SUBJECT: PRELIMINARY SITE PLAN REVIEW (SP JPLN2025-0004) – Proposed Zenith Retail and Multifamily Apartments, Northwest corner of Wattles and Dequindre (PIN 88-20-13-478-024 & 88-20-13-478-025), Section 13, Currently Zoned NN (Neighborhood Node “E”) District

Preliminary Site Plan For City of Troy, Michigan

Action Requested: Preliminary Site Plan Approval

LP - 1: LANDSCAPE PLANTING PLAN
* Base data provided by Survey Tech.

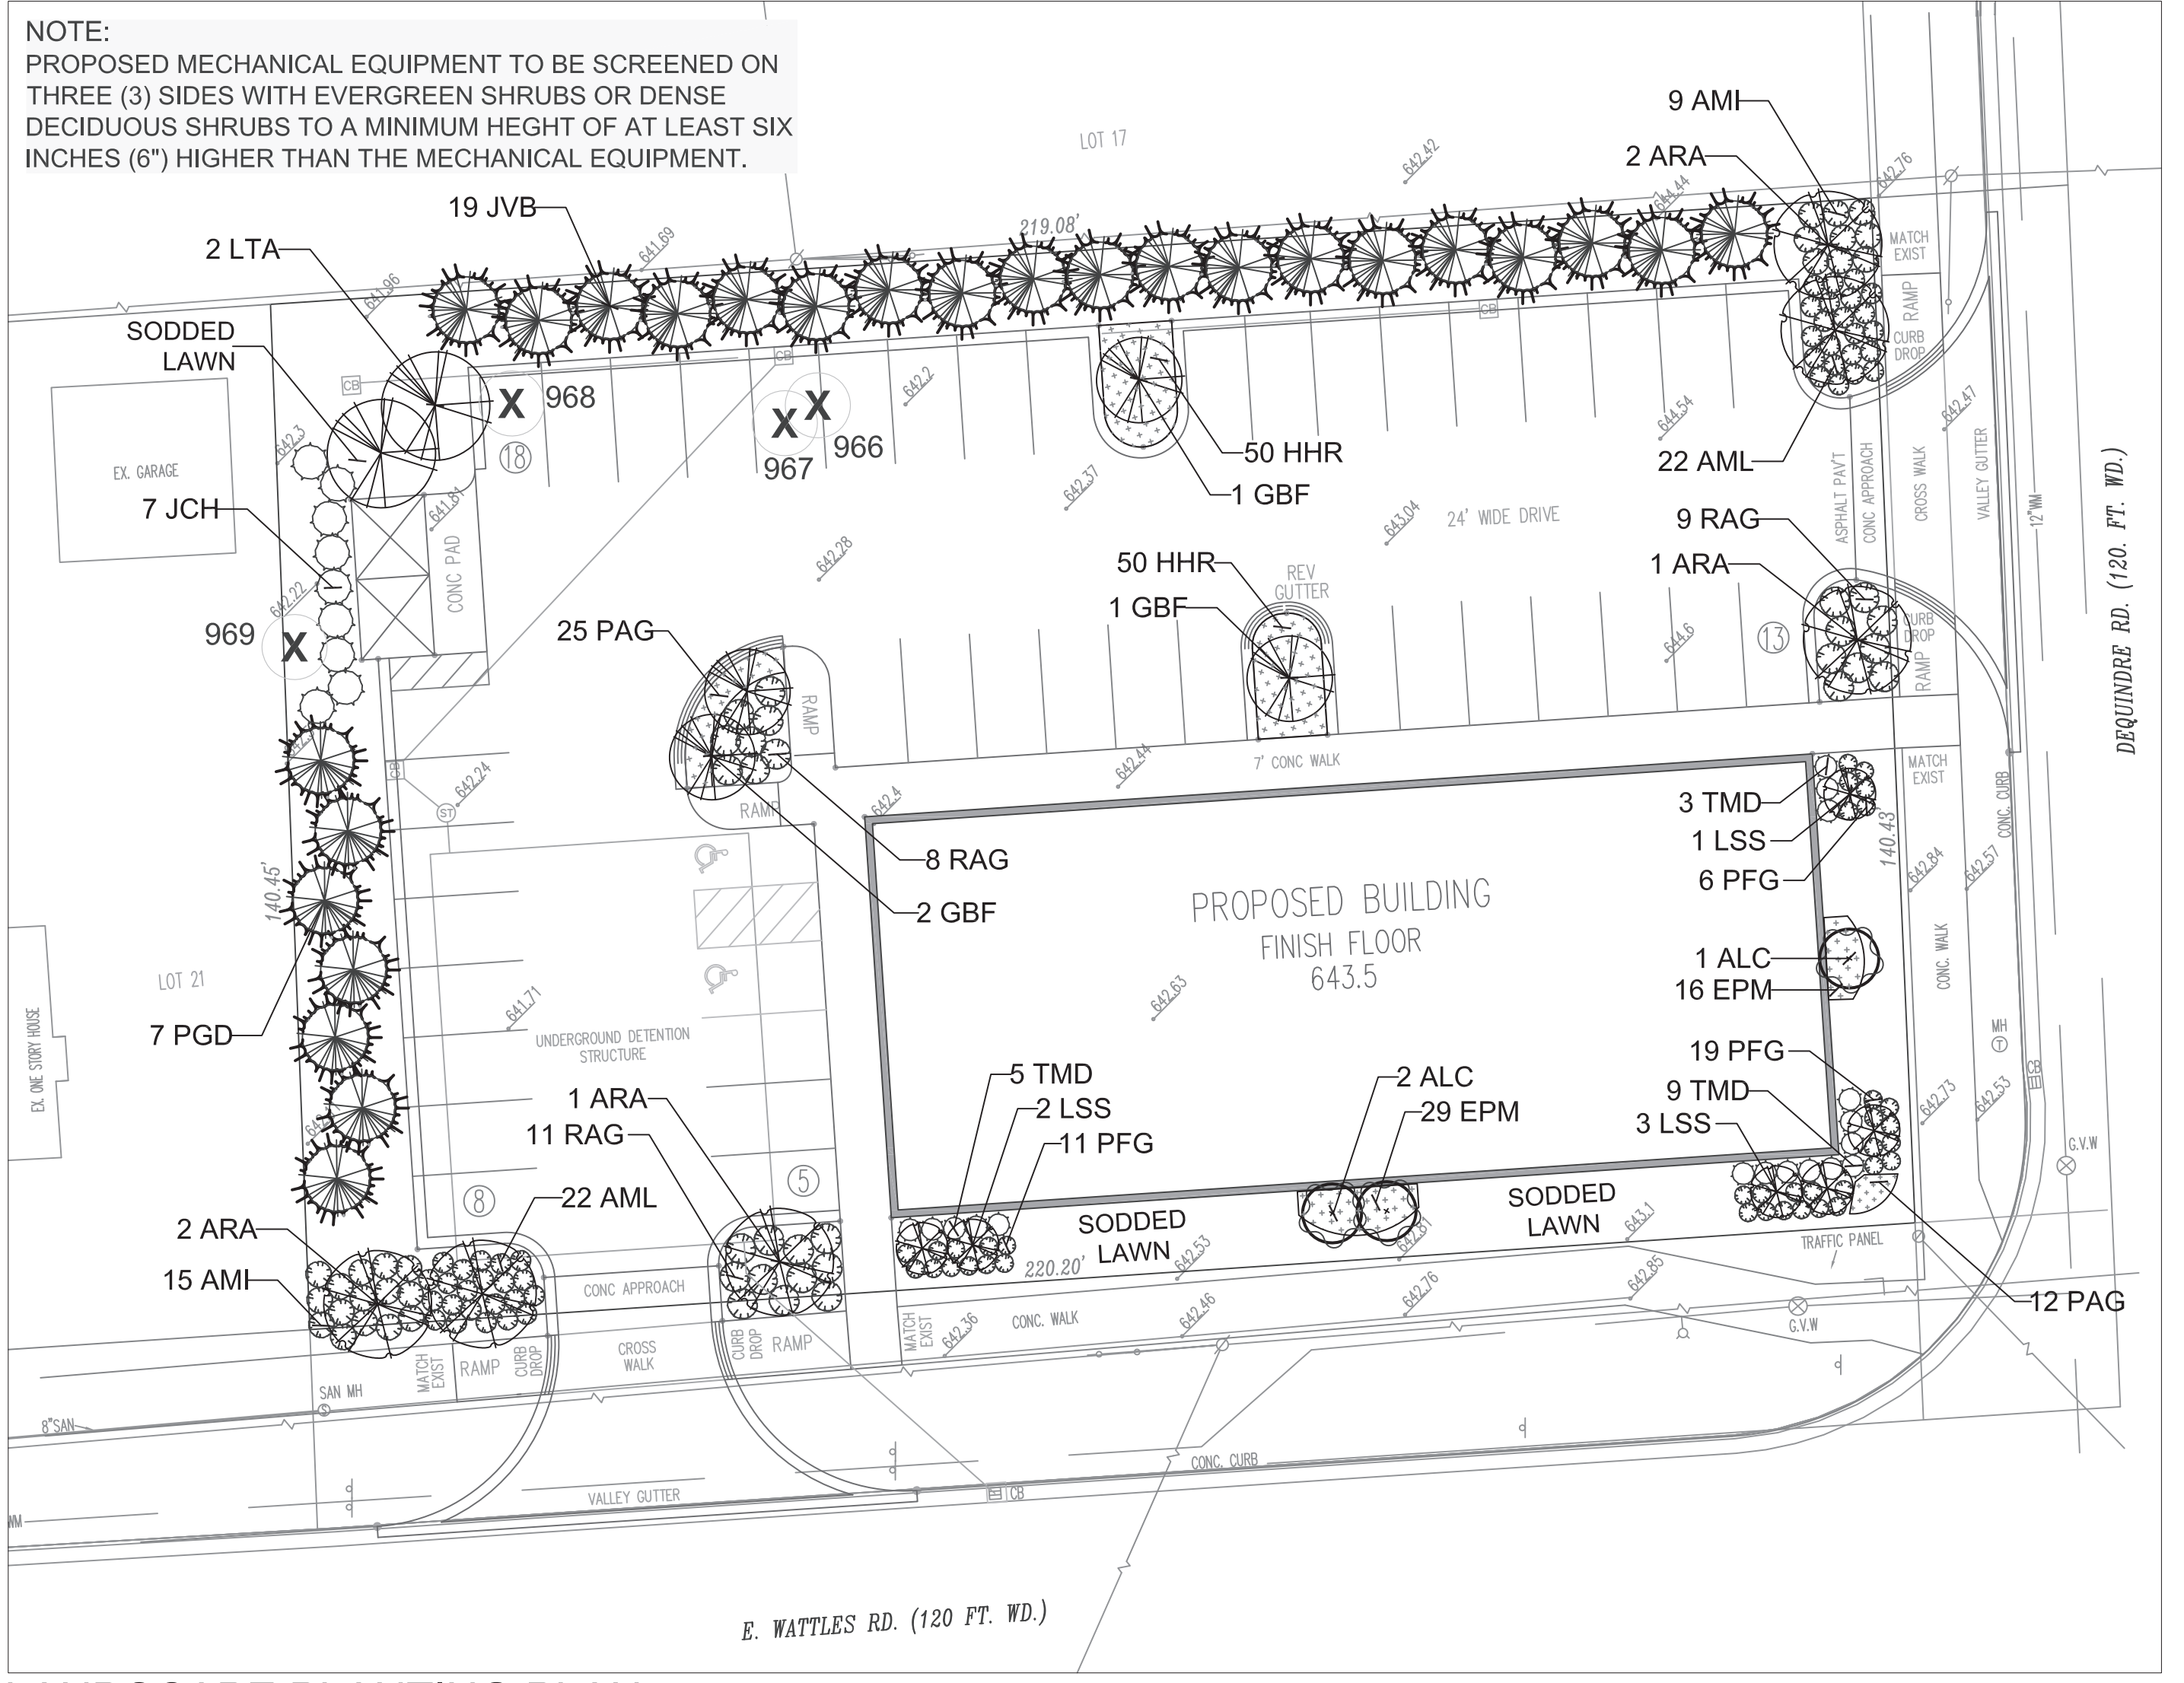
Sheet C-1 shows that three (3) bicycle stalls will be provided on a concrete pad near the northwest corner of the building. However, this contradicts information provided on the landscape plan. In the same location, the landscape plan on Sheet LP-1 shows this area covered with grasses, eight (8) shrubs, and two (2) trees.

The landscape plan indicates that parking lot landscaping requirements have been met. However, as previously mentioned, there is a discrepancy between the landscape plan and site plan. Where two (2) parking lot trees are proposed on Sheet LP-1, a concrete pad with bicycle parking is shown on Sheet C-1. We ask the applicant to revise plans so that these sheets match and all parking and landscaping requirements are fulfilled.

The proposed location of mechanical equipment is unclear. Notes on Sheet LP-1 indicate that mechanical equipment will be located outdoors and properly screened. Yet, no mechanical equipment is shown on the site plan on Sheet C-1. In addition, there is an unnamed sheet that shows mechanical equipment on the roof. We recommend that the applicant verifying the location of all mechanical equipment should be a condition of approval.

1. *Bring landscape screening along the north property line into compliance.*
2. *Revise plans to correct discrepancy between Sheets C-1 and LP-1, where bicycle parking and landscaping are shown in the same location. In doing so, ensure that bicycle parking and parking lot landscaping requirements remain fulfilled.*
3. *Verify the location of mechanical equipment.*
4. *Clarify whether "wood" will be natural wood or wood composite.*
5. *Provide transparency calculations that measure transparency between two and eight feet above the first floor elevation.*
6. *Elevation and floor plan drawings to be sealed by Michigan licensed Architect*
7. *Provide 3D color renderings showing site context.*

SCALE: 1"=20'	DATE: 12-09-2024	JOB #: 24121	SHEET: C-1
DRAWN BY: M.M.F.	CHECKED BY: D.R.	APPROVED BY:	
REVISED: 02-18-2025 PER REVIEW

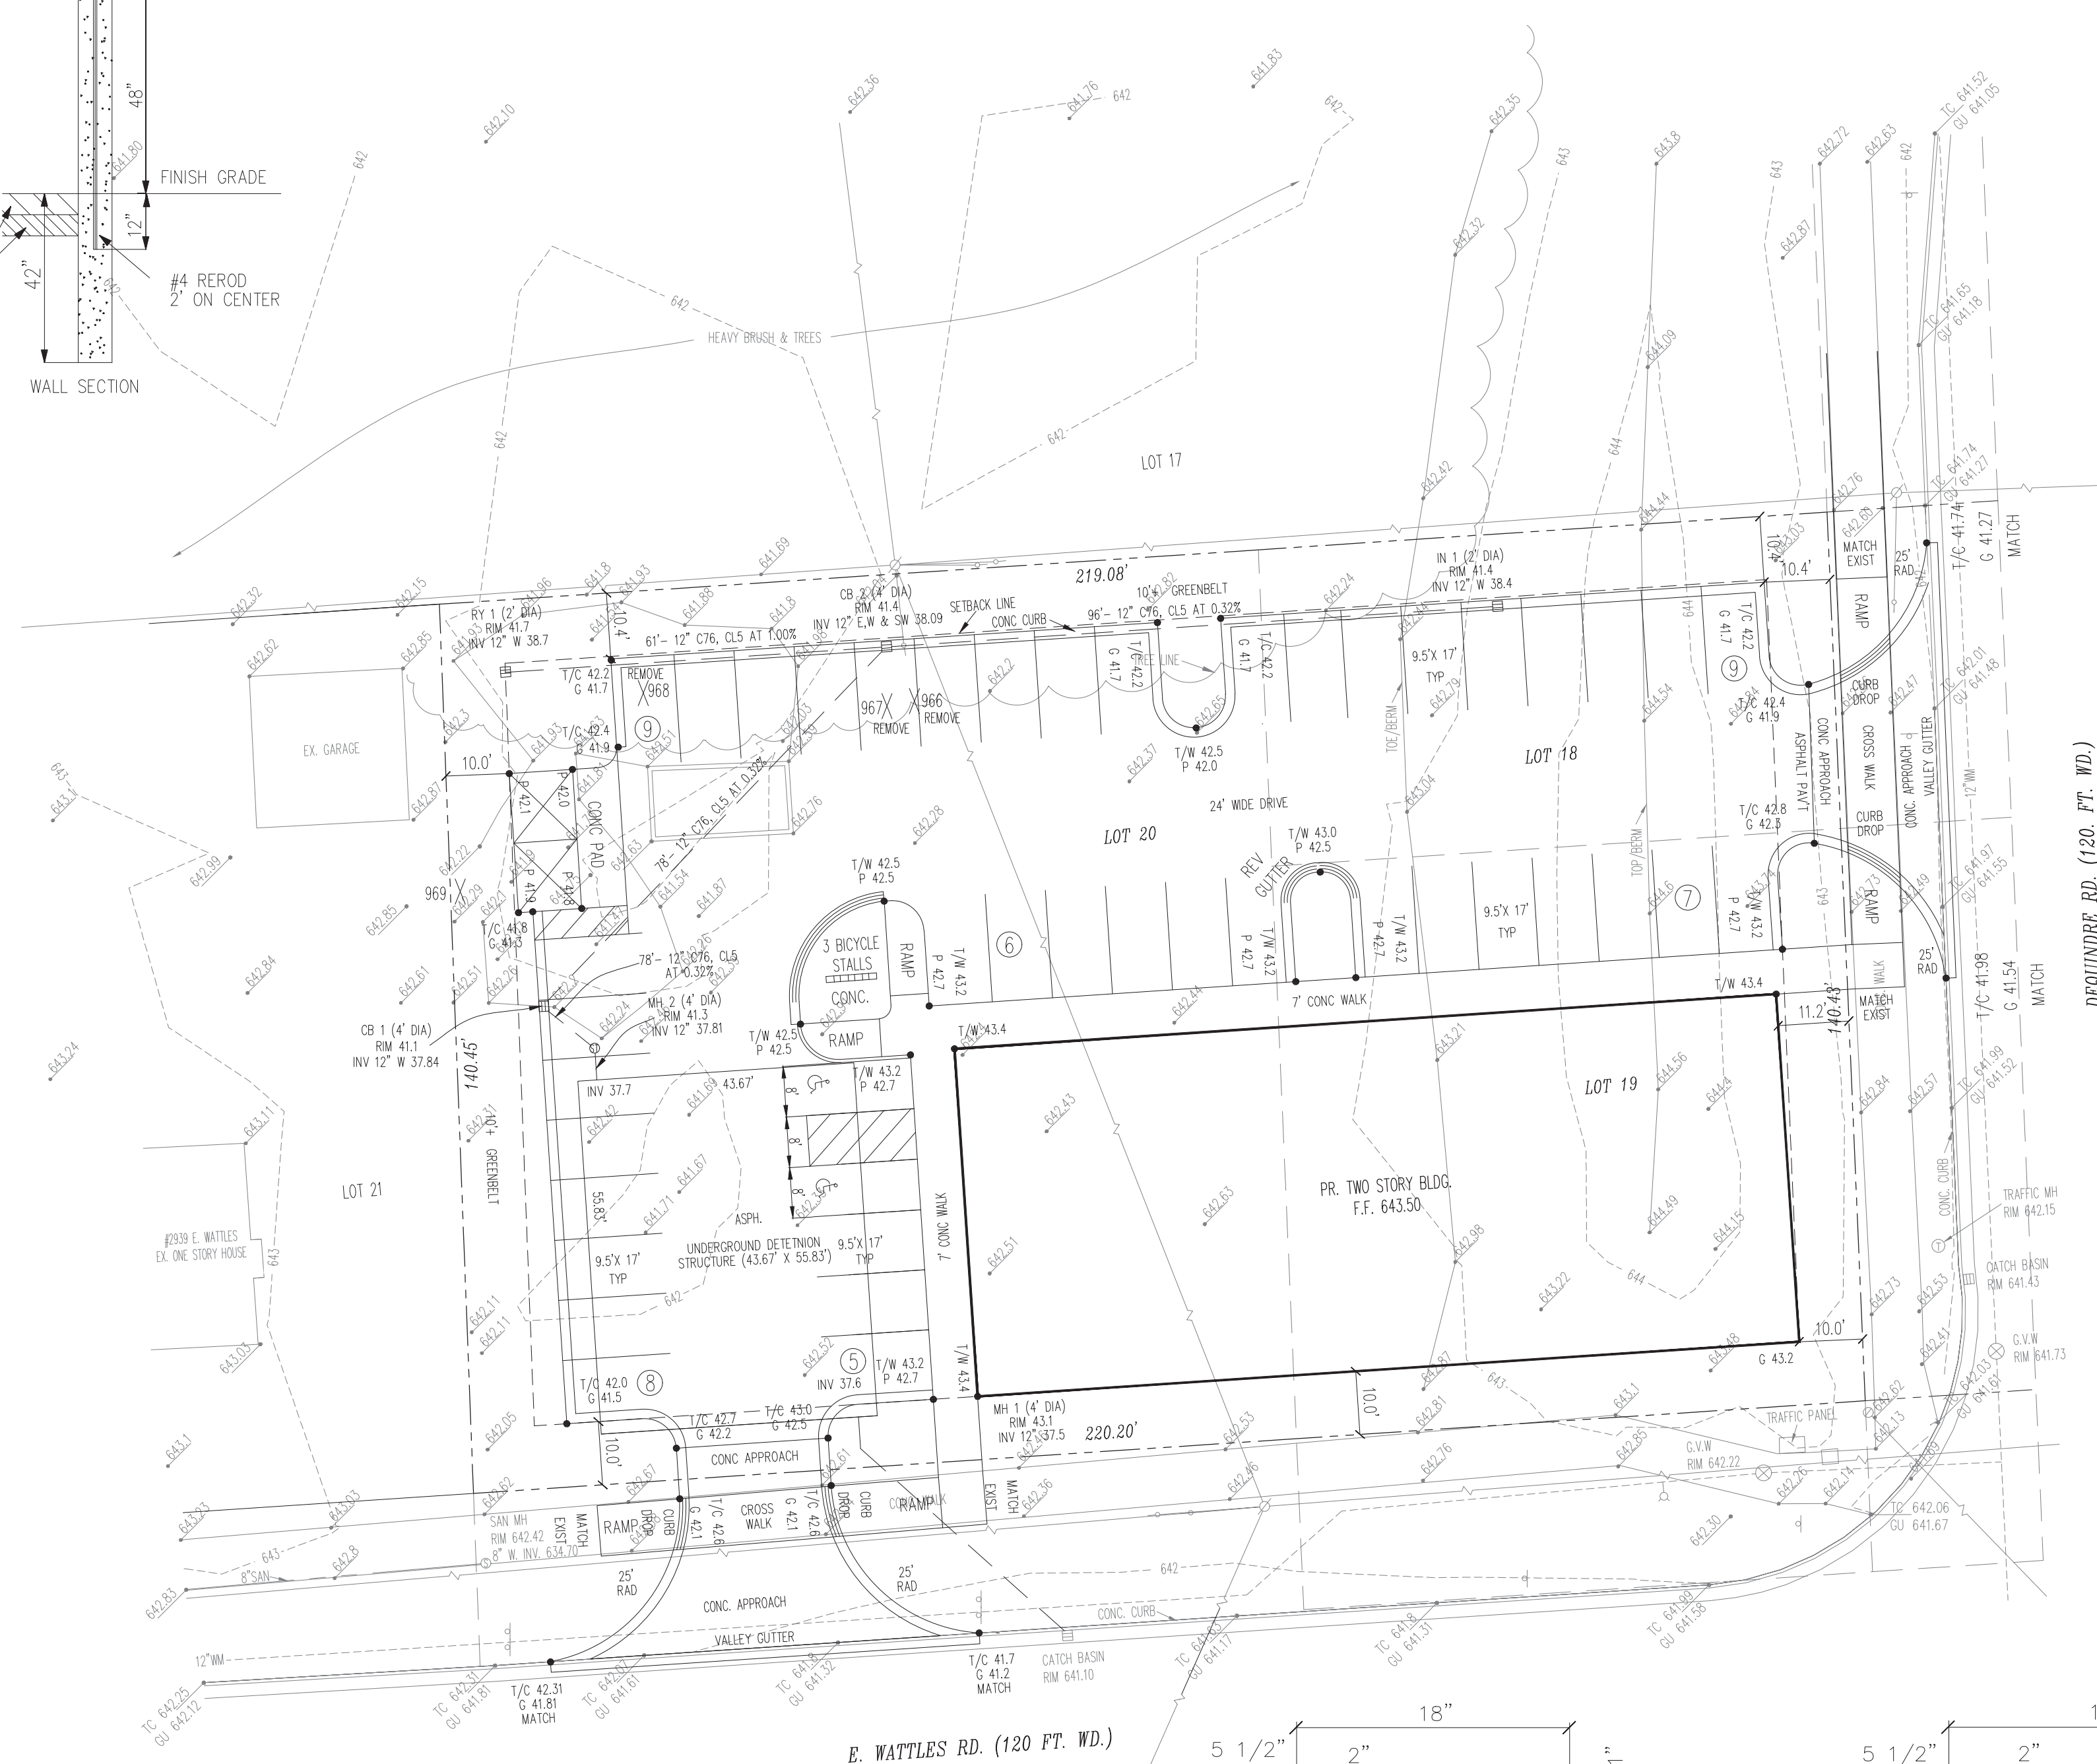
Items to be Addressed: *Revise plans to correct discrepancy between Sheets C-1 and LP-1, where bicycle parking and landscaping are shown in the same location.*

West elevation

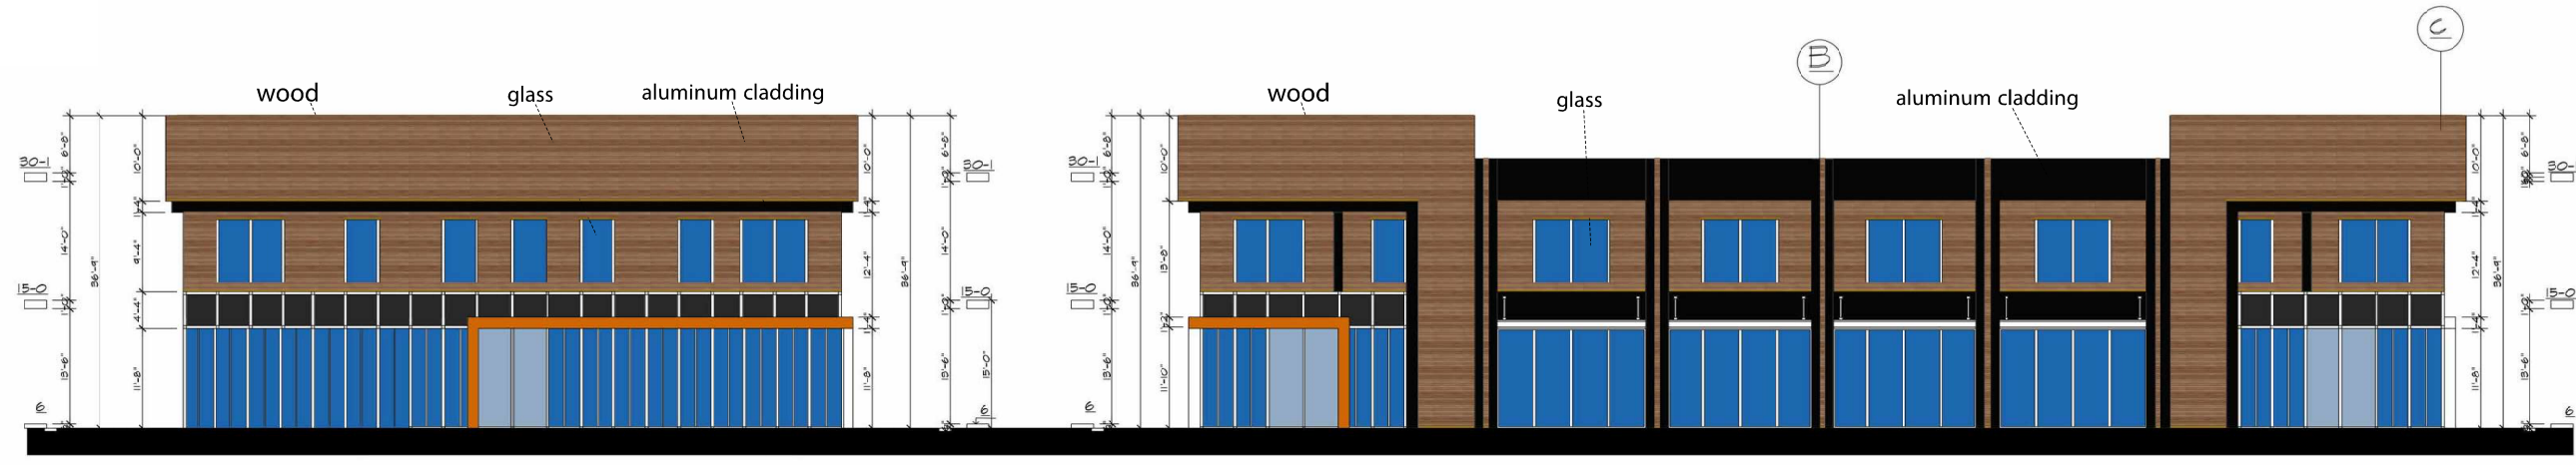
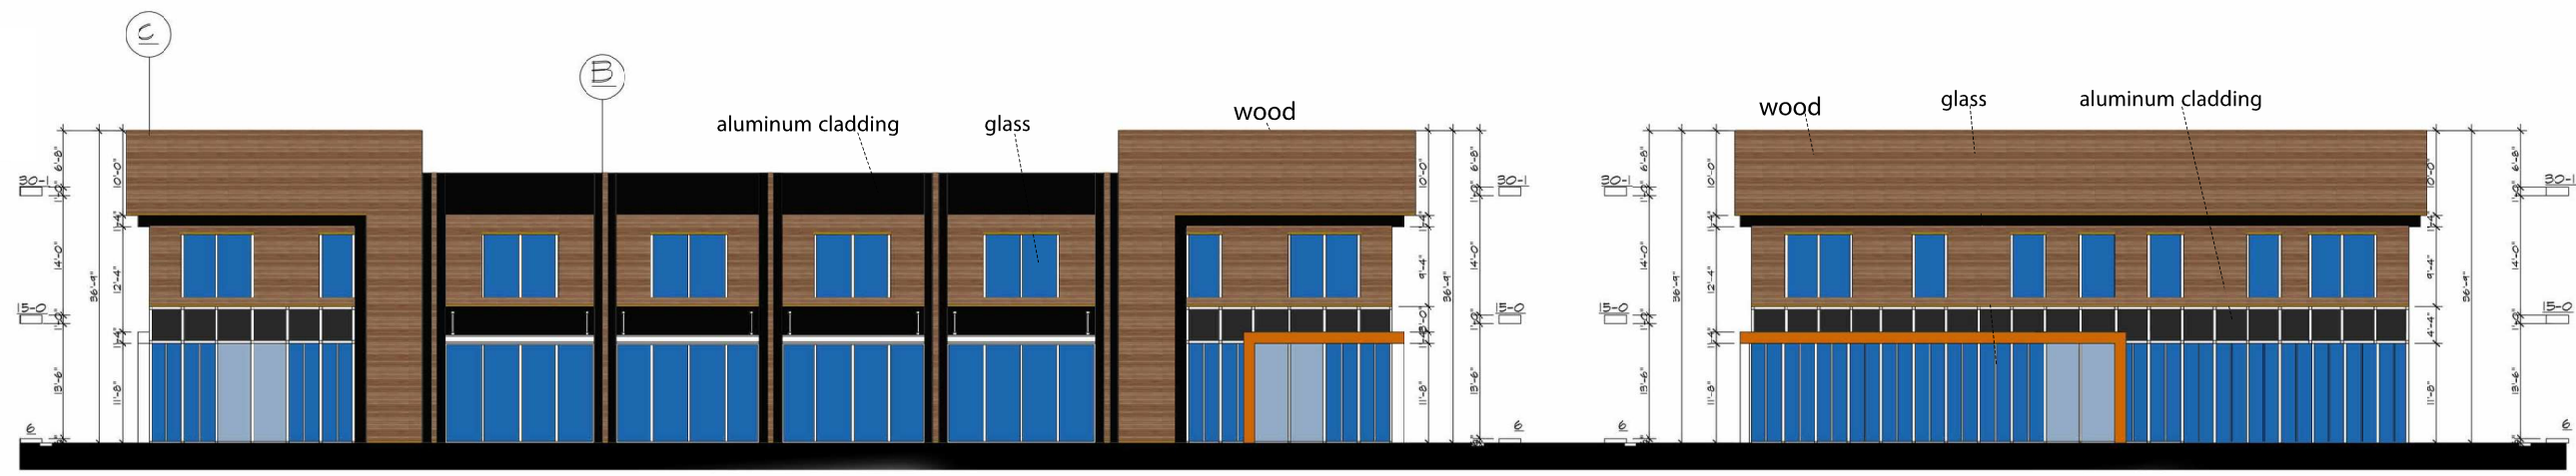
Elevation and floor plan drawings were not sealed by a Michigan licensed Architect.

The building features a flat-roof design with an overall height of 36 feet 9 inches. A rendered elevation drawing was provided however 3D color renderings showing site context were not provided.

Primary building materials include aluminum cladding, wood, and glass. Exterior colors are shown as black, brown, and orange. We ask the applicant to clarify whether the "wood" refers to natural wood or some type of wood composite.

Items to be Addressed: 1.) Elevation and floor plan drawings to be sealed by Michigan licensed Architect; 2.) Clarify whether wood will be natural wood or wood composite; and 3.) Provide transparency calculations that measure transparency between two and eight feet above the first floor elevation; 4.) Provide 3D color renderings showing site context.
